THE ROCK CHURCH SUBDIVISION

APPLICATION NUMBER 18 DATE November 3, 2005
APPLICANT The Rock Church Subdivision
REQUEST Subdivision

THE ROCK CHURCH SUBDIVISION

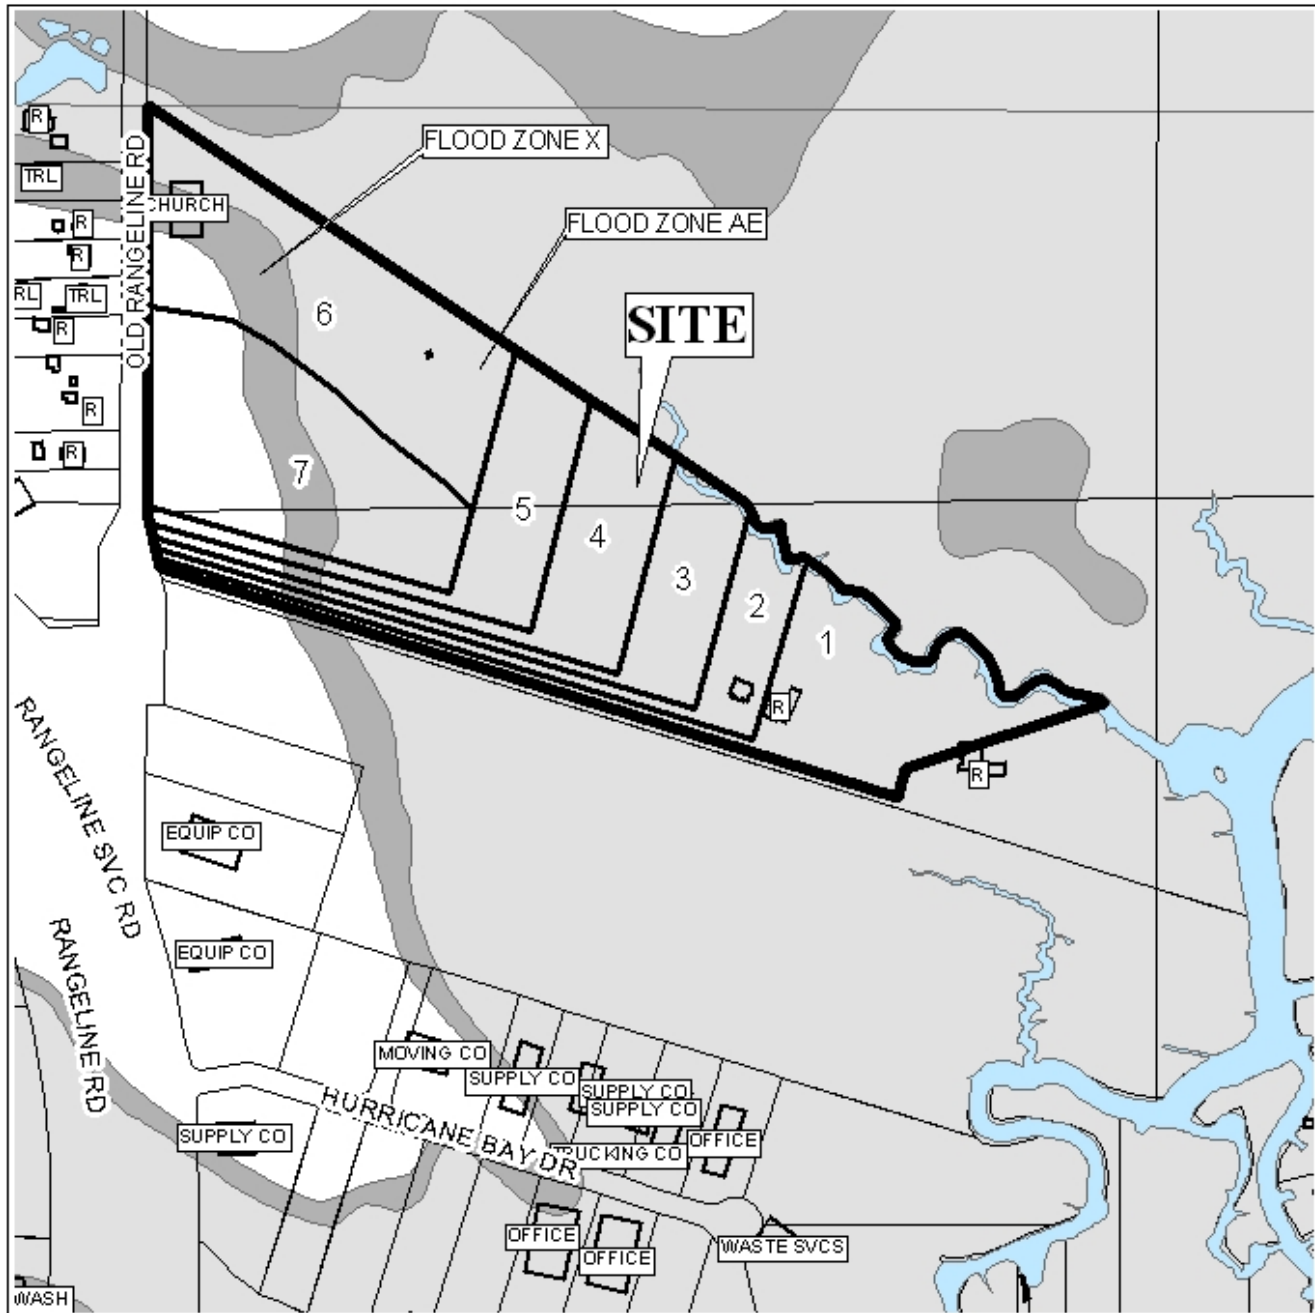
The site is located north of the intersection of Old Rangeline and Rangeline Roads. While Old Rangeline Road has an adequate right-of-way, the size of the site in question creates access management concerns. The approved subdivision in 2003 restricted the site in question to a maximum of two curb-cuts onto Old Rangeline Road; this restriction should be carried into the application currently under consideration.

Lots 1- 5 are proposed to be flag-lots with 25-foot wide strips ranging from approximately 741 feet to 1,626 feet in length, connecting them to Old Rangeline Road. If the "pole" portion of the flag-lots is excluded, all proposed lots meet the recommended depth to width ratios of Section V.D.3. Lots in the vicinity of Alligator Bayou exhibit high depth to width ratios due to the desirability of waterfront lots and the extensive wetlands in the area. Flag-lots exist along the Alligator Bayou / Dog River area, however, they create an undesirable land subdivision condition which, in this case, could easily be remedied through the provision of a public street following the existing access road on the site, or via the creation of an innovative subdivision with a private street, in conformance with Section VIII. of the Subdivision Regulations.

The site is within the drainage basin for Alligator Bayou, a tributary to Dog River. In addition to existing wetlands, much of the site appears to be located within floodplains associated with Alligator Bayou. Furthermore, the site appears to be located in an area subject to hurricane-related storm surges. The presence of wetlands and floodplains on the site indicate that the area may be environmentally sensitive; therefore, the approval of all applicable federal, state and local agencies would be required prior to the issuance of any permits.

The site is located in the County, thus a note should be placed on the final plat stating that any lots which are developed commercially and adjoin residentially developed property must provide a buffer, in compliance with Section V.A.7. of the Subdivision Regulations.

Based upon the preceding, the application is recommended for Holdover for the following reasons: 1) redesign of the proposed subdivision to provide access via a public street, or creation of an innovative subdivision with private street, in conformance with Section VIII. of the Subdivision Regulations.
